**STAFF RECOMMENDATION**  
**1910 Linden Avenue**  
**April 16, 2014**

**Application:** New construction-addition and outbuilding; Setback determination  
**District:** Belmont-Hillsboro Neighborhood Conservation Zoning Overlay  
**Council District:** 18  
**Map and Parcel Number:** 10416013300  
**Applicant:** Preston Quirk, architect  
**Project Lead:** Paul Hoffman, paul.hoffman@nashville.gov

**Addition to Residence**  
Mr. Phillip Stinson  
1910 Linden Avenue  
Nashville, TN 37212

Figure 2. Rear of house showing the bay and porch on the left to be removed for the addition

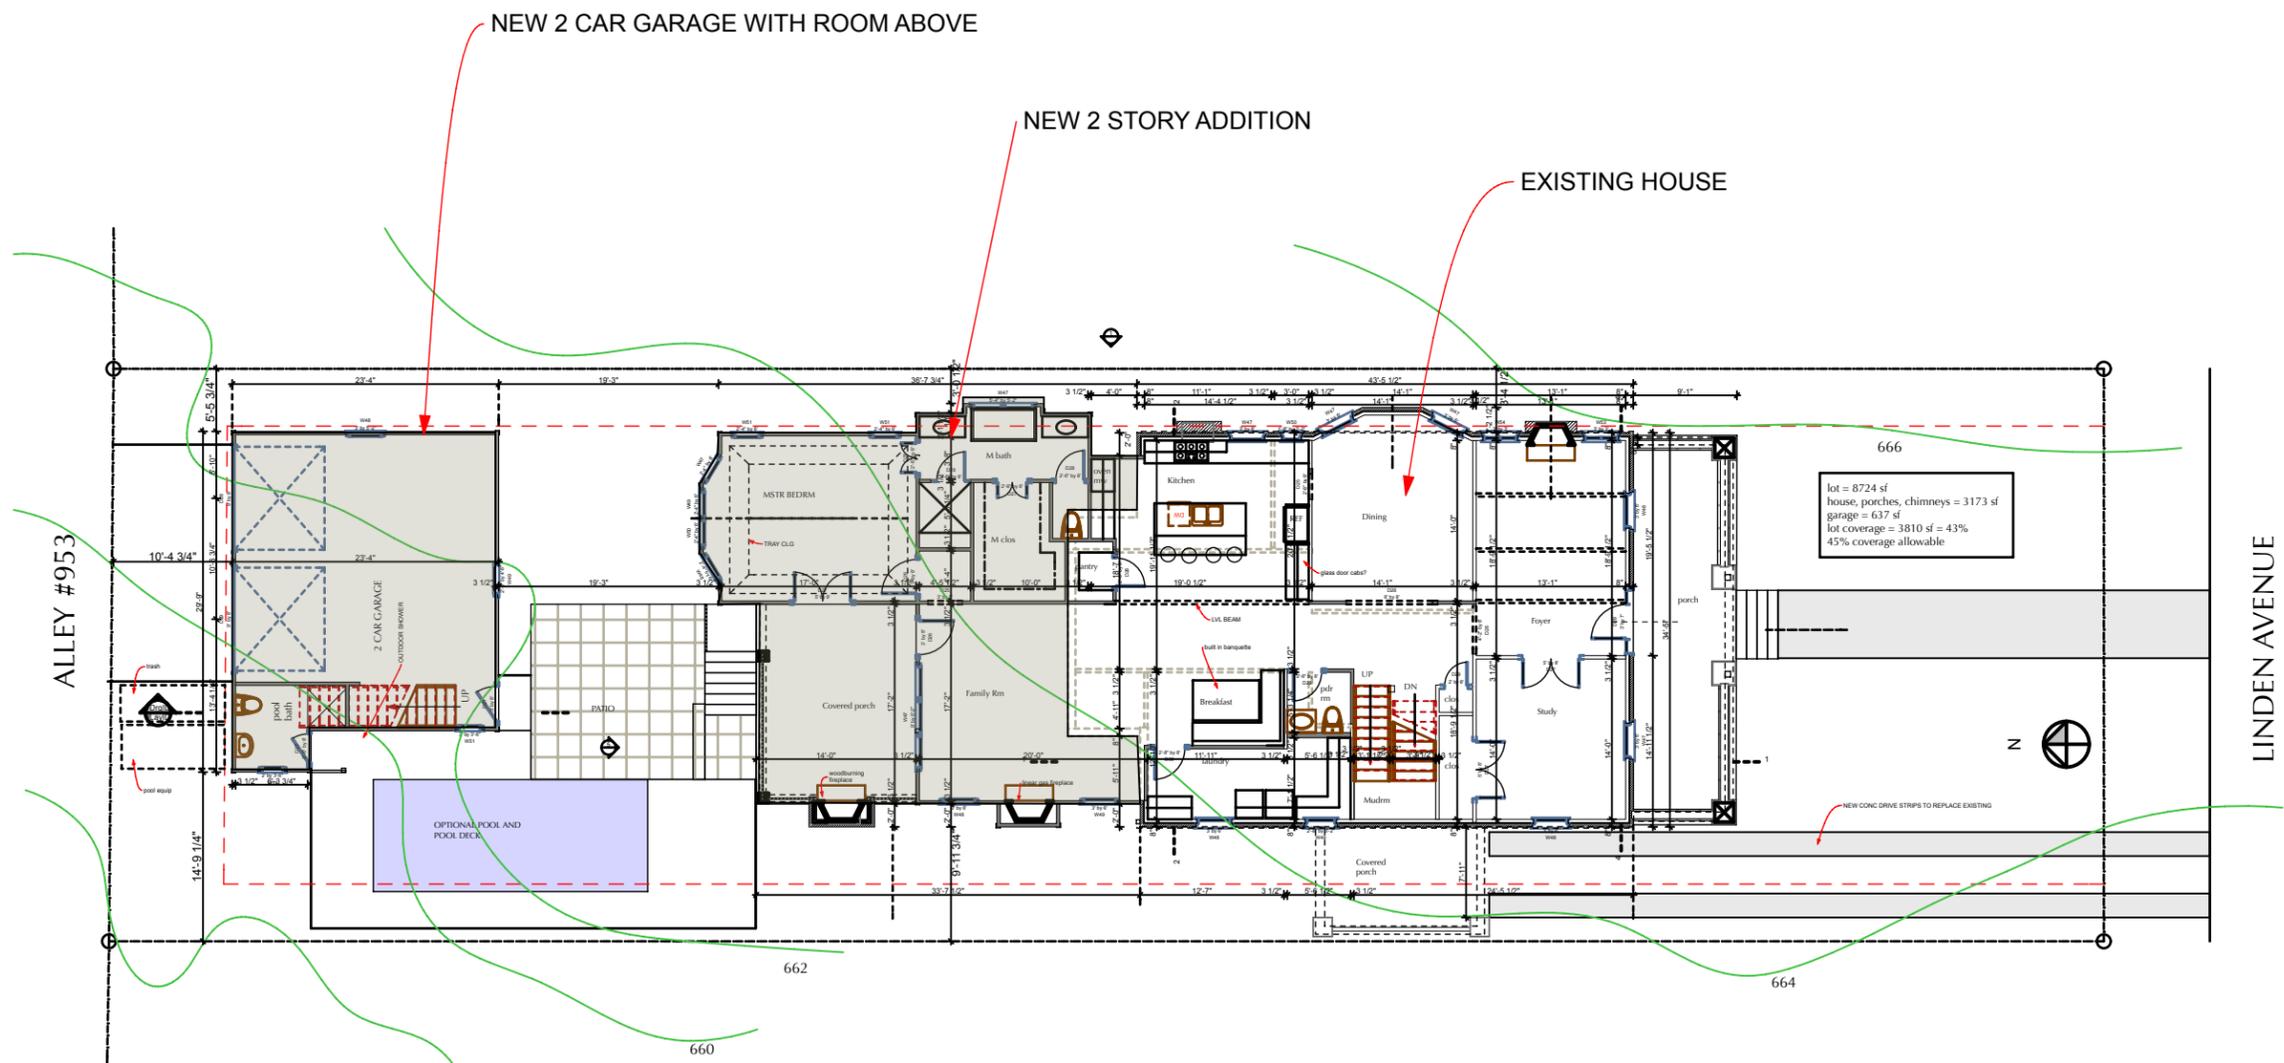
Demolition: The project includes the demolition of a rear porch and bay. Although these are original to the house, they are not character-defining features of the house and will not affect its historical integrity. Staff finds this partial demolition meets section III.B.2 for appropriate demolition and does not meet section III.B.1 for inappropriate demolition.

SITE PLAN

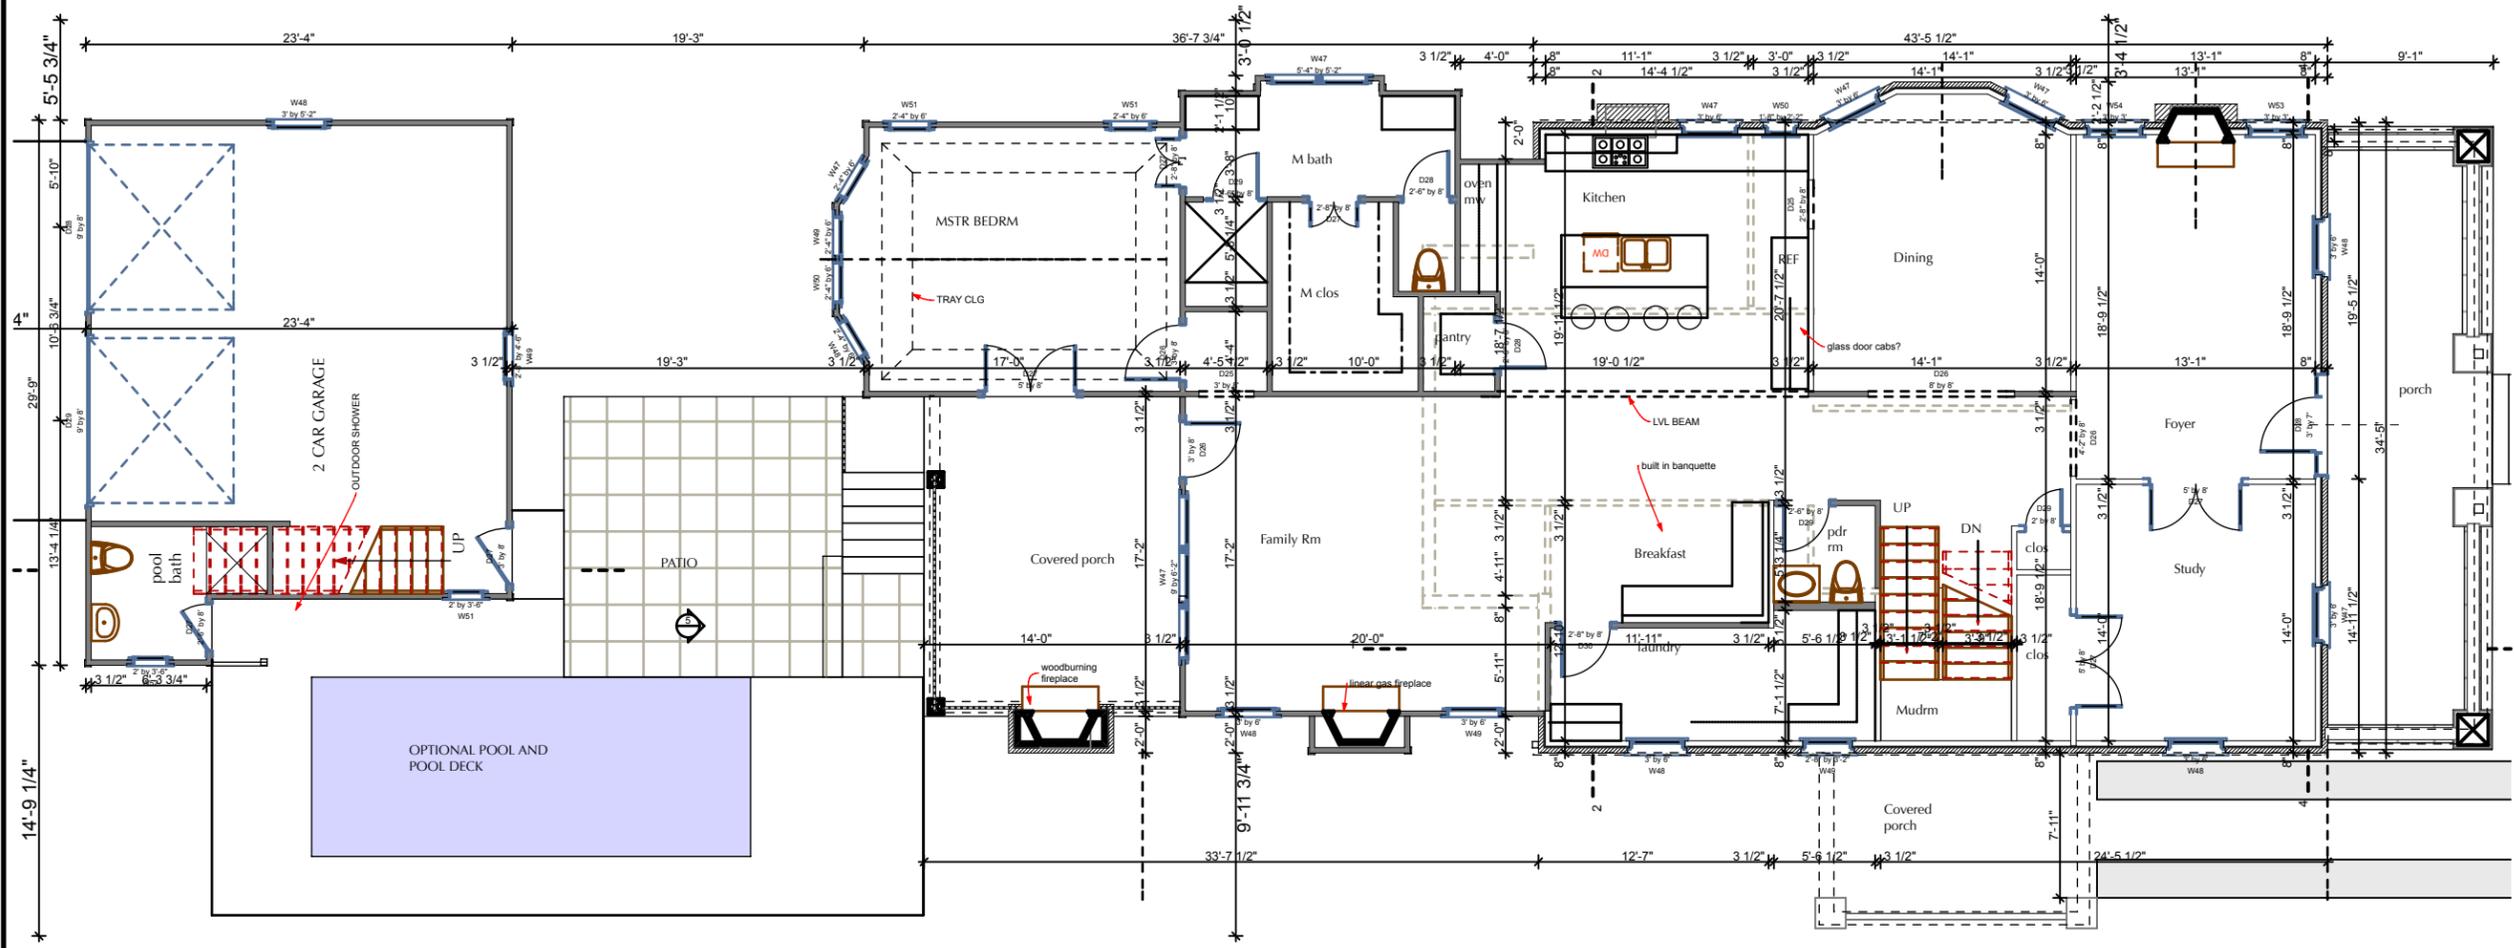
Setback & Rhythm of Spacing: The addition will be fifty-two feet (52') from the rear property line, three feet, four inches (3'4") from the right side and nine feet eleven inches (9'11") from the left. Although the addition is no wider than the house, a setback determination is requested from five feet (5') to three feet, four inches (3'4") for the right side. Approximately fifteen feet (15') of this side of the addition will be in the setback area. Staff finds this setback to be appropriate because the historic house does not meet the base zoning setback of five feet (5') and the addition matches that width. The project meets section II.B.1.c and II.B.2.

Appurtenances & Utilities: Changes to the site's appurtenances are new concrete strips to replace the existing drive from Linden, and a concrete driveway proposed to access the garage from the alley. A pool and pool deck are shown on the site plan, but details were not provided. The location of the HVAC and other utilities was also not noted. Staff asks that the HVAC be located on the rear façade, or on a side façade beyond the midpoint of the house. The project meets section II.B.1.h.
